STAFF REPORT

AGENDA ITEM: Final Plat and Planned Unit Development (PUD) Plans and Conditional Use

Permit for Day Care Facility to be called Growing Explorers Learning Center

The City has received a set of applications from Shamsi, LLC for Final Plat and PUD Plans and a conditional use permit for Outlot A of Boulder Ponds.

ROJECT NUMBER: XXXXX **GRADING PLAN**

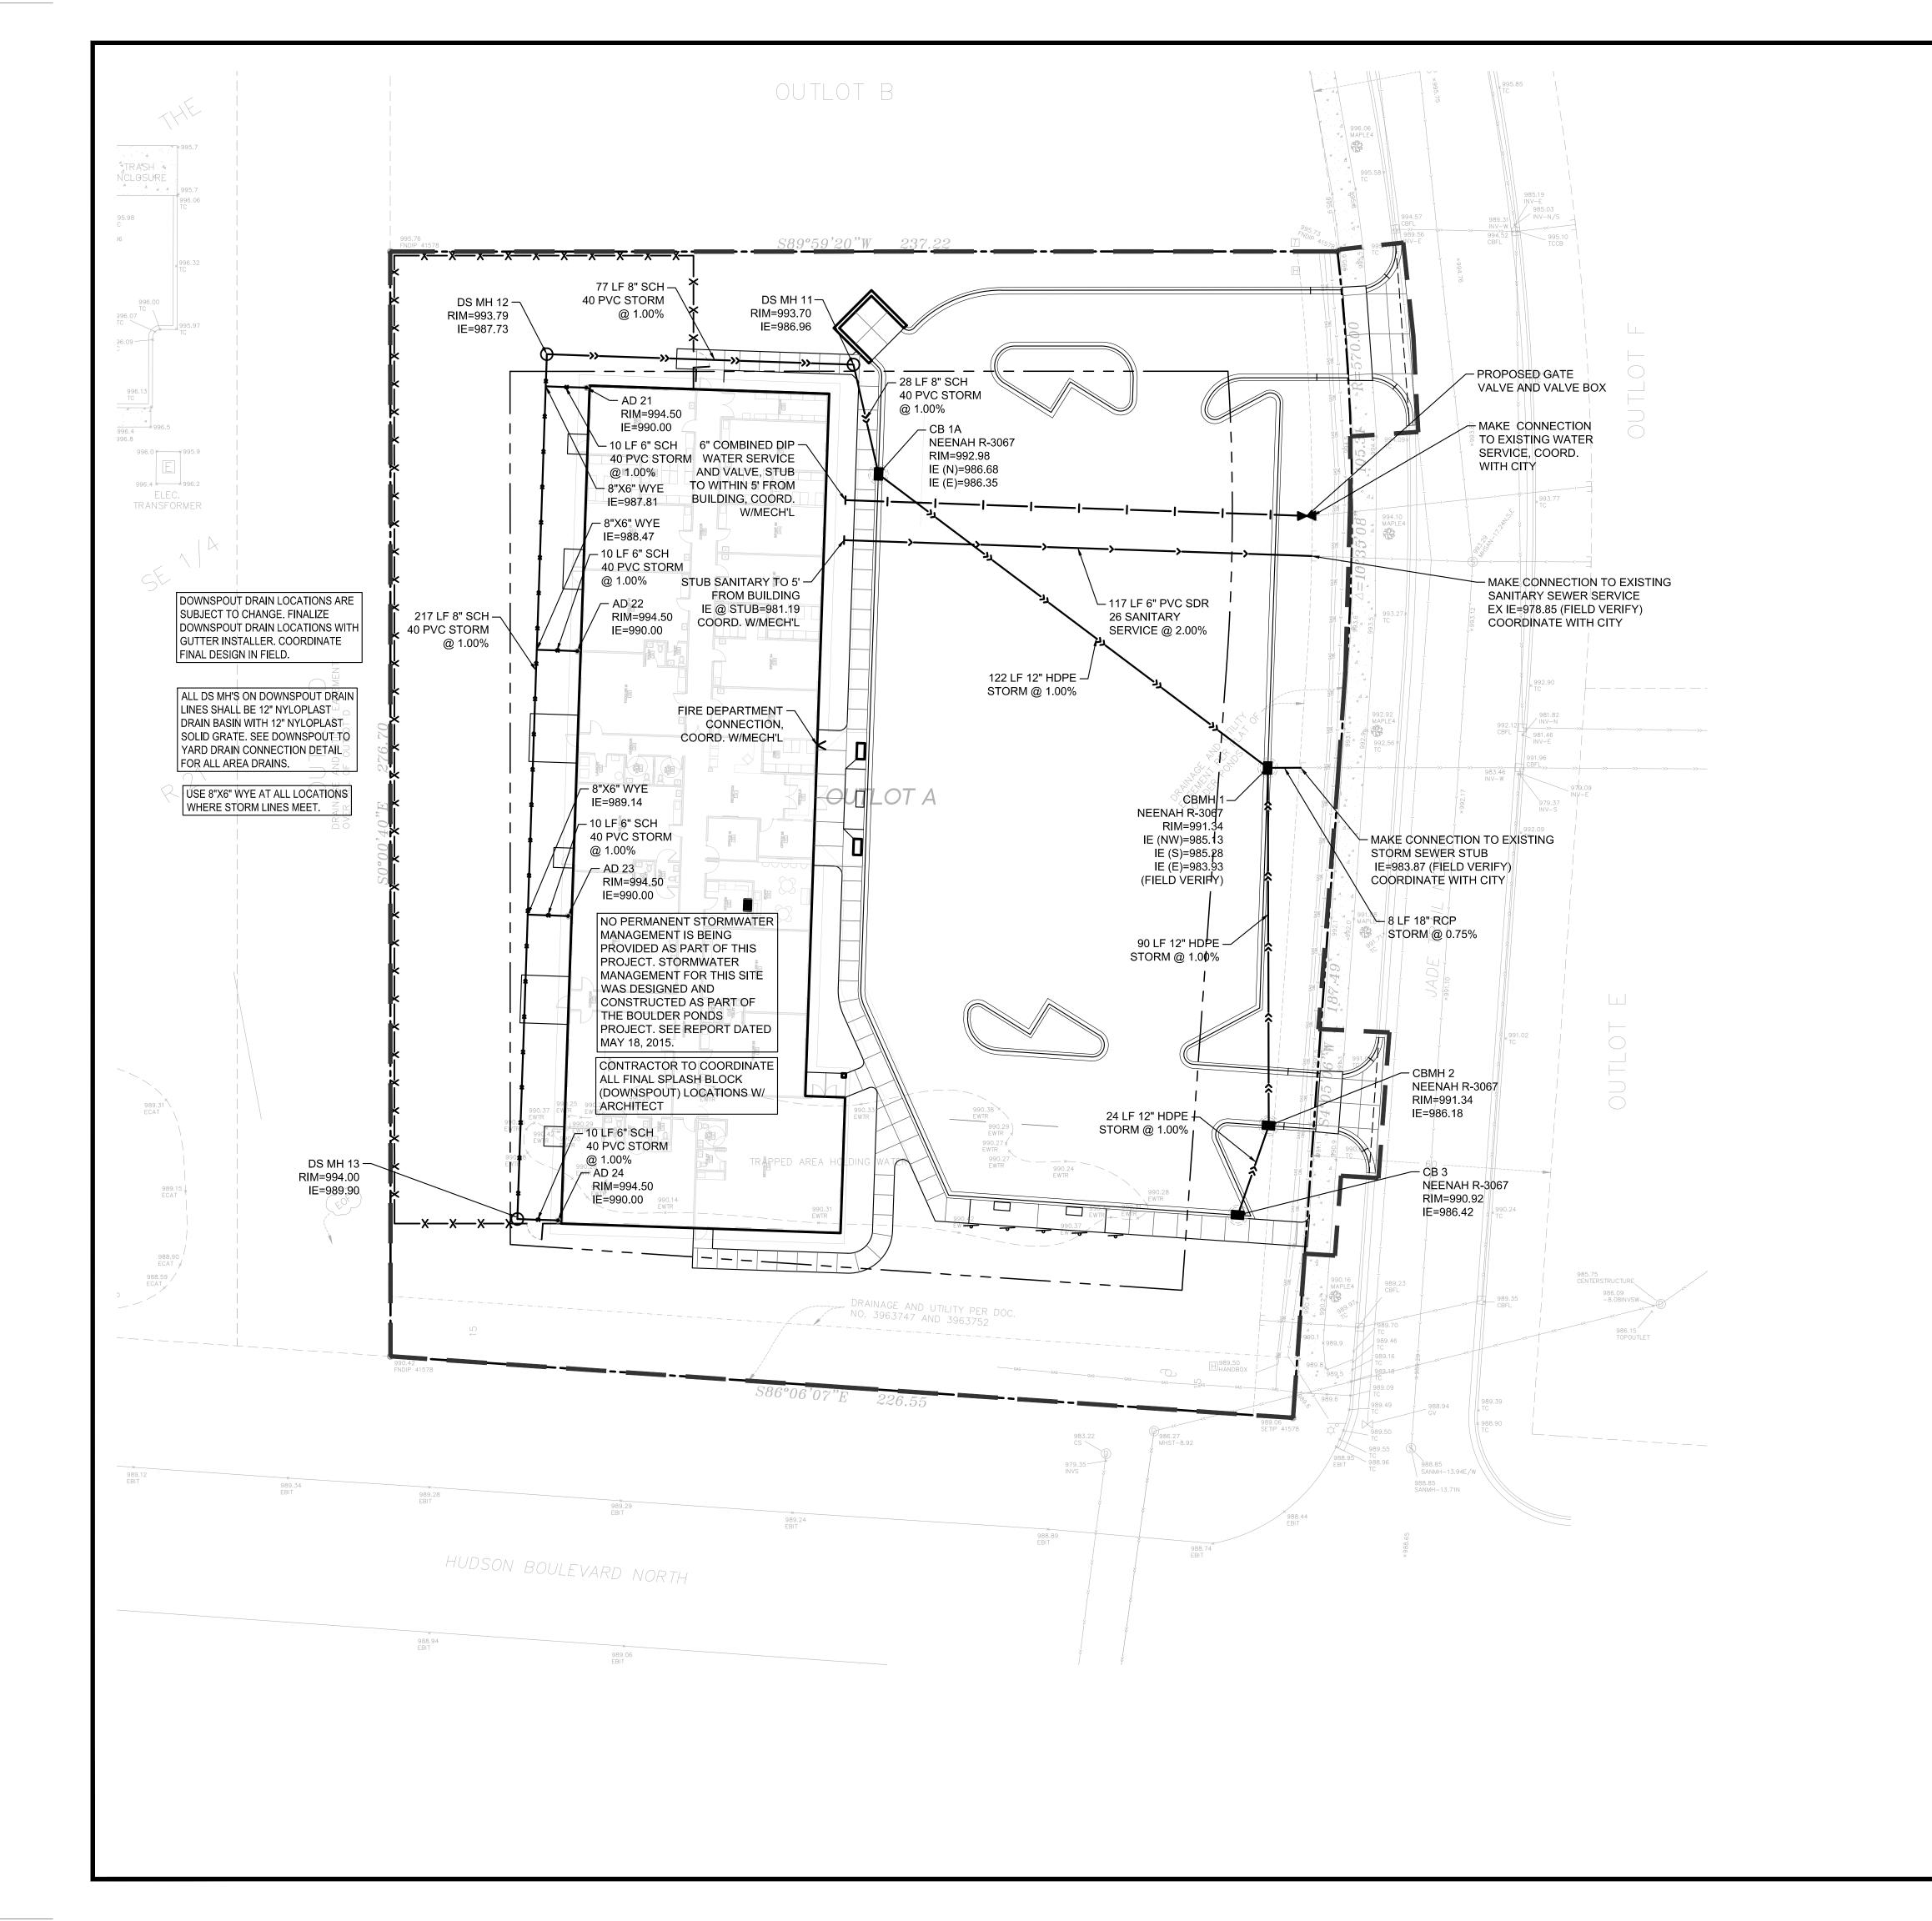
- 1. C3.0. Add City standard plan notes (City Detail 600D) to the grading plan sheet. Remove any general grading notes that conflict with City standard plan notes.
- 2. C3.0. Add plan note indicating that 100% building roof run roof must be captured and conveyed to the storm water basin located on the east side of Jade Trail North. No building roof runoff is allowed to drain to the infiltration basin/drainage swale located to the west side of the proposed building.

UTILITY PLAN

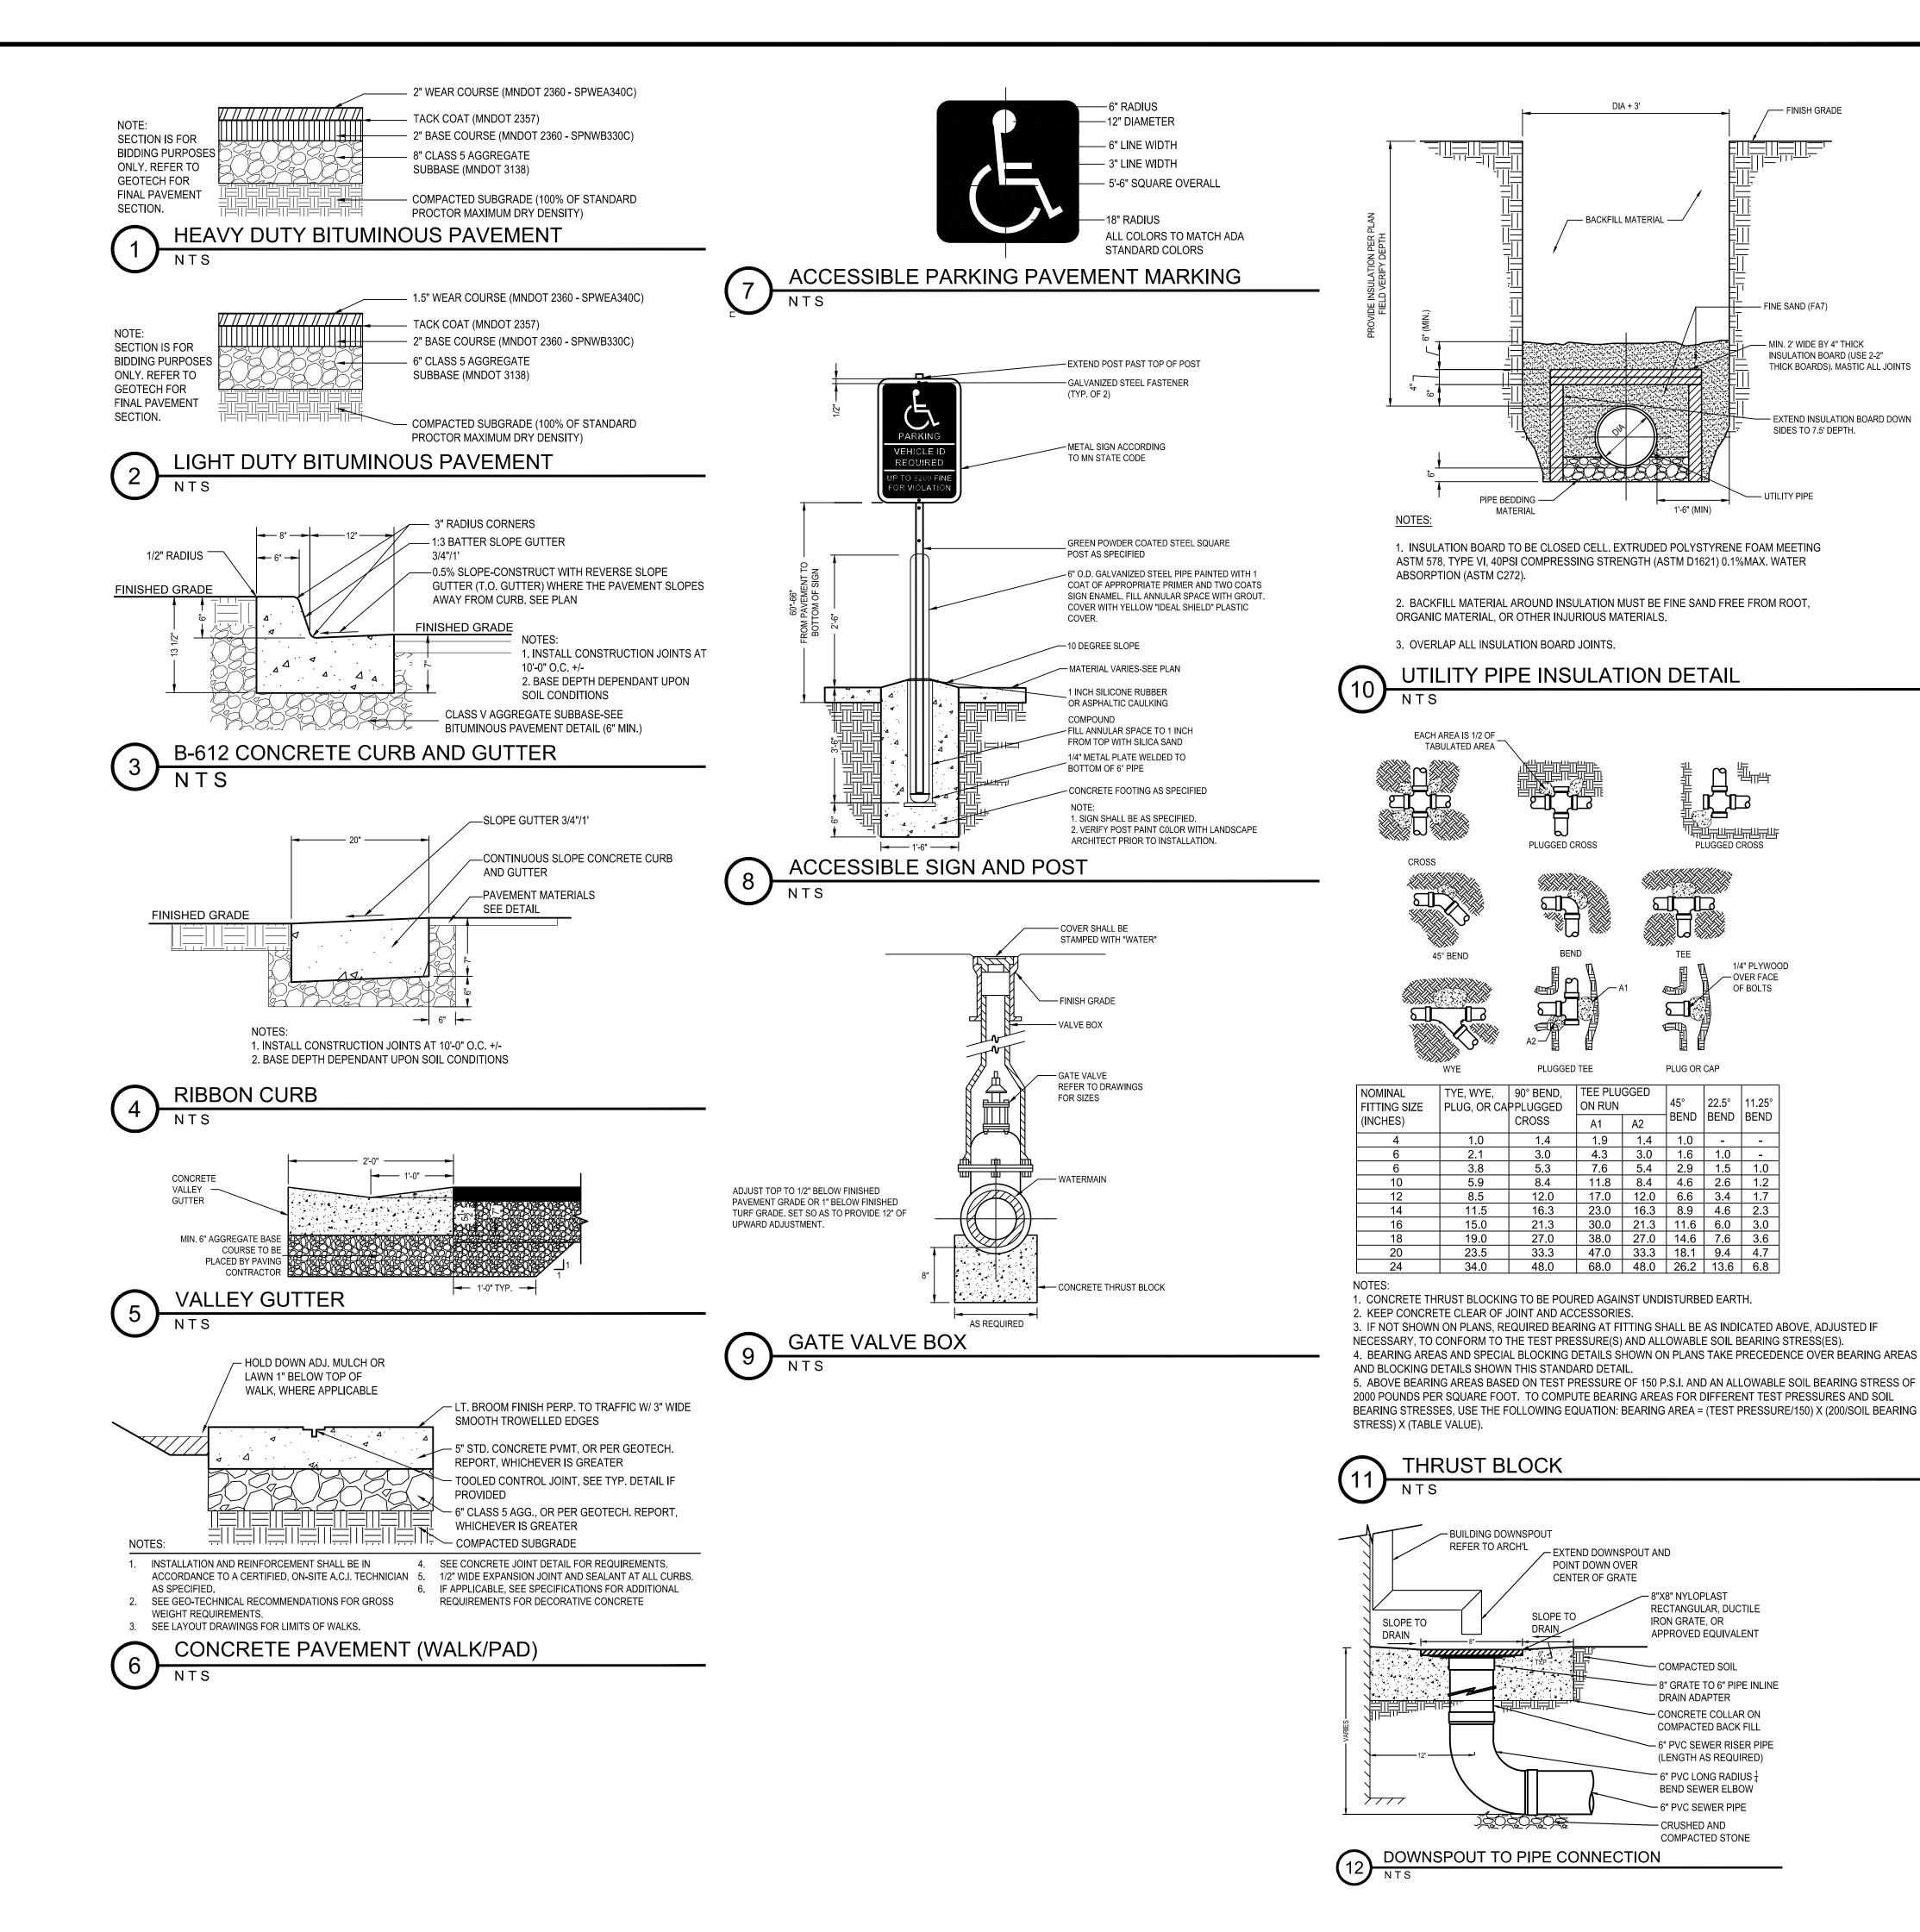
- 3. C4.0. Add plan note indicating that 100% of the building roof runoff must be captured and conveyed to the storm water basin located on the east side of Jade Trail North. No roof runoff is allowed to drain to the infiltration basin/drainage swale located west of the proposed building on Boulder Ponds Outlot D.

- 3. C4.0. Identify irrigation service locations, if any, and coordinate landscape plan and utility plan accordingly.
- 4. Fire Hydrant locations. No new fire hydrants have been proposed. There is one existing fire hydrant located along Jade Trail North approximately 110 feet north of the north Outlot A property line. If fire hydrants are required to be placed interior to the site of Outlot A, the fire hydrants and connecting watermain will be City owned and maintained. If required, the site and utility plans, and project specifications must be revised and resubmitted for City review, showing the proposed hydrants and connection watermain using City design standards, details and specifications. Utility easements must be dedicated to the City, minimum width of 30-feet centered over the pipe and hydrants, and all easements must be shown on the Site Plan, Utility Plan and Grading Plan. City standard plan notes for watermain must be shown on the utility plans.

ROJECT NUMBER: XXXXX CIVIL DETAILS

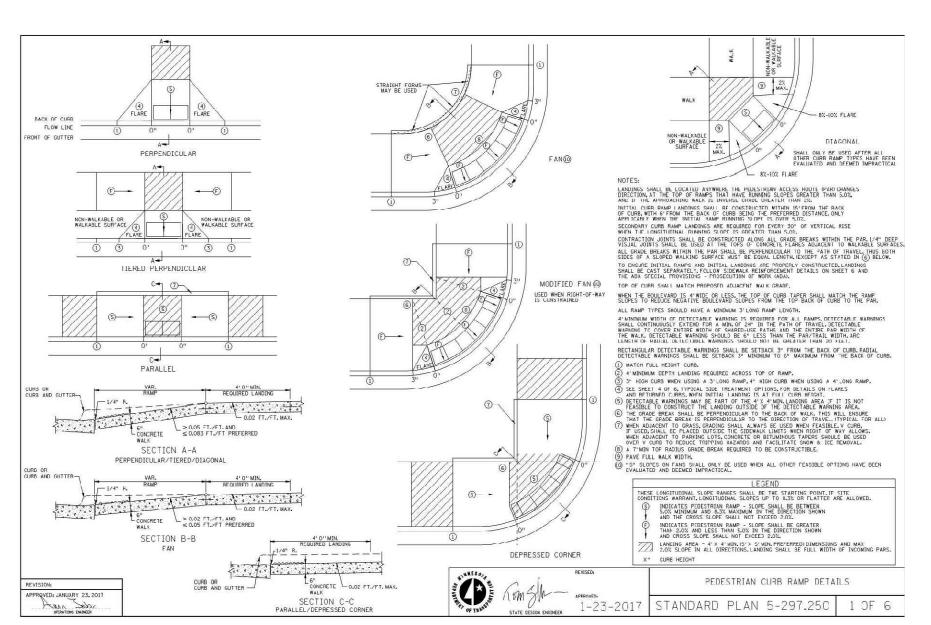
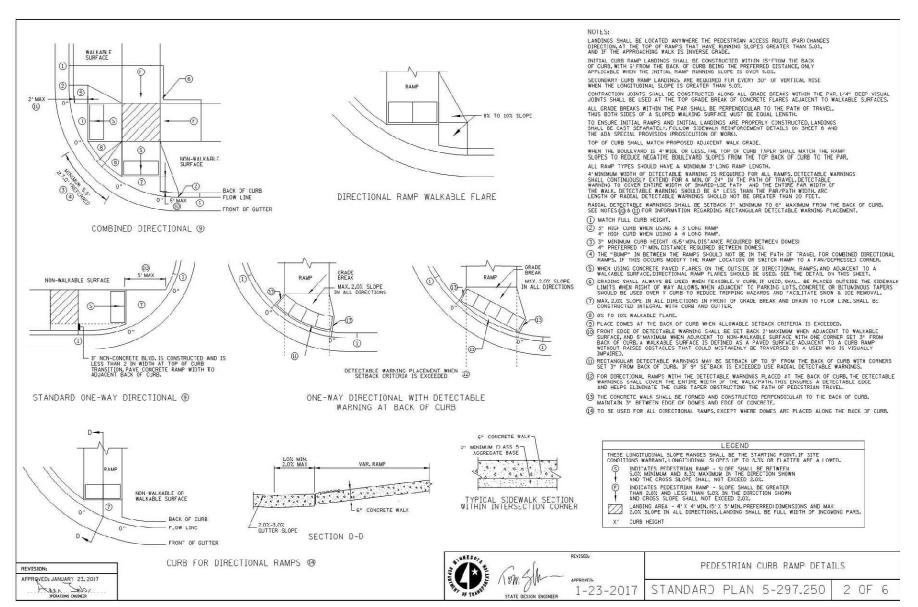
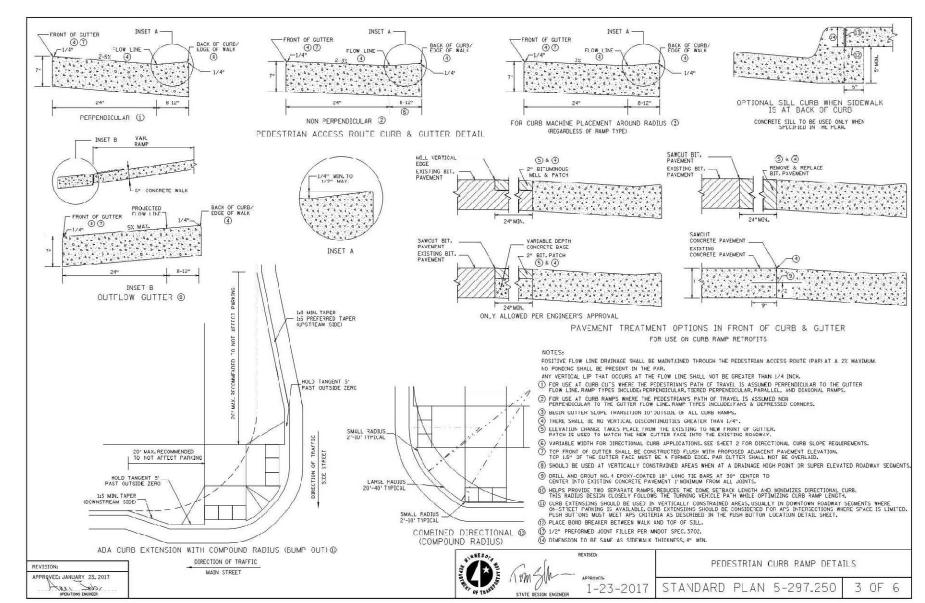
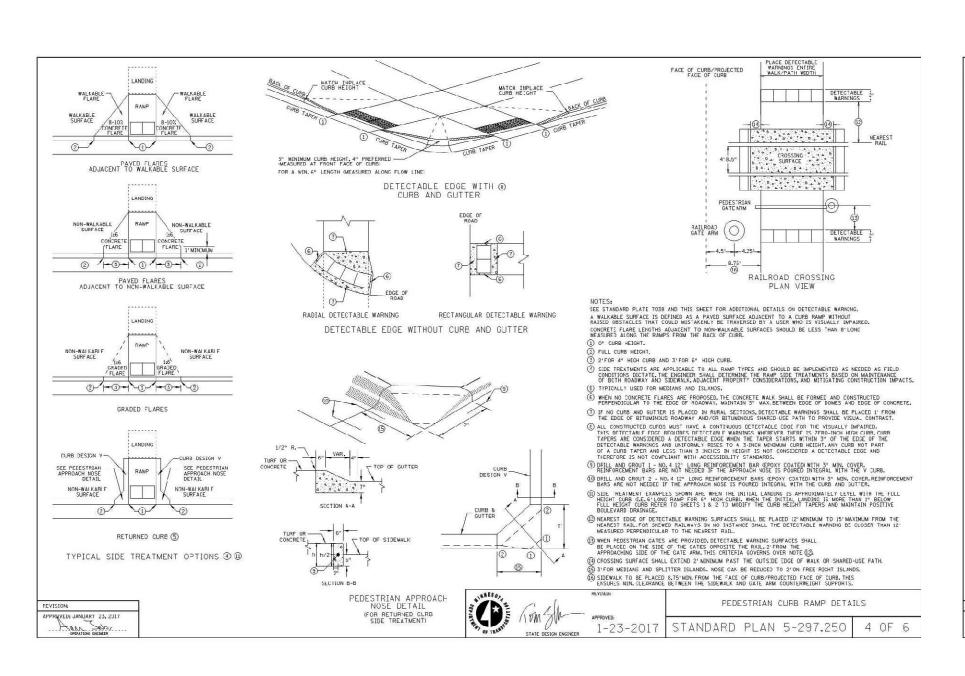
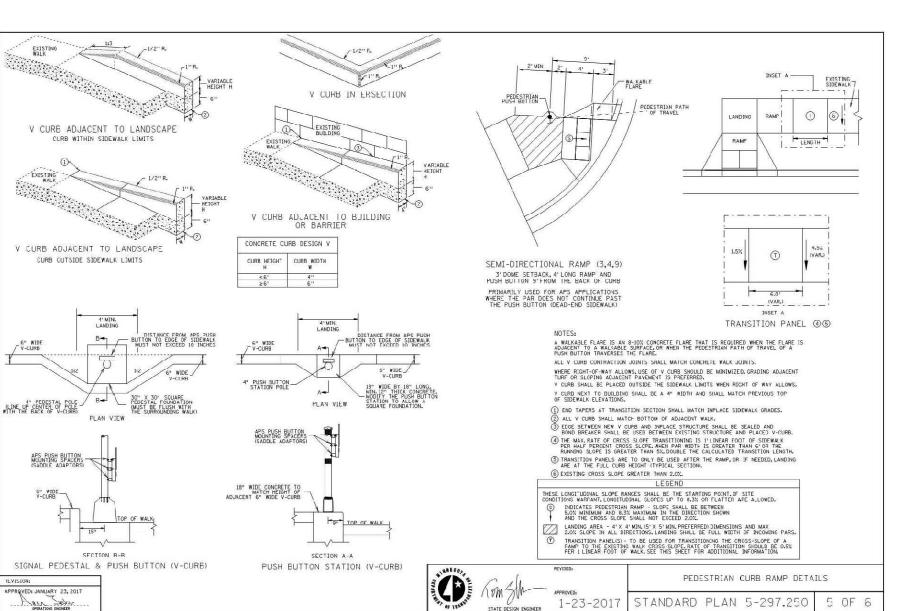
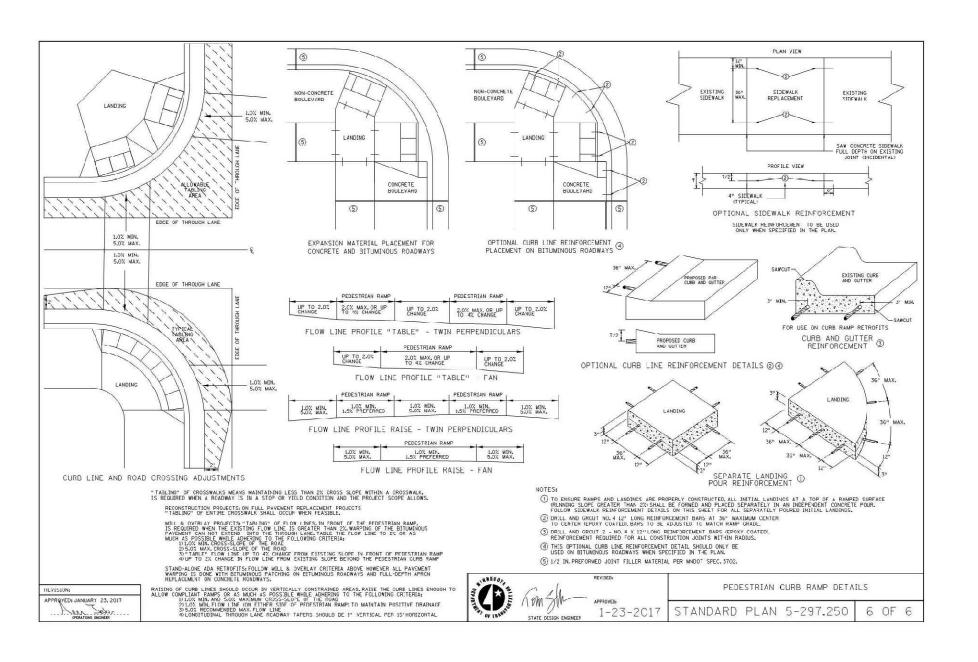
1. C5.0 and C5.1. Add City details 201, 203, 208, 407, 501, 502, 505, 506, 508, 510, and 513. Remove duplicate details.
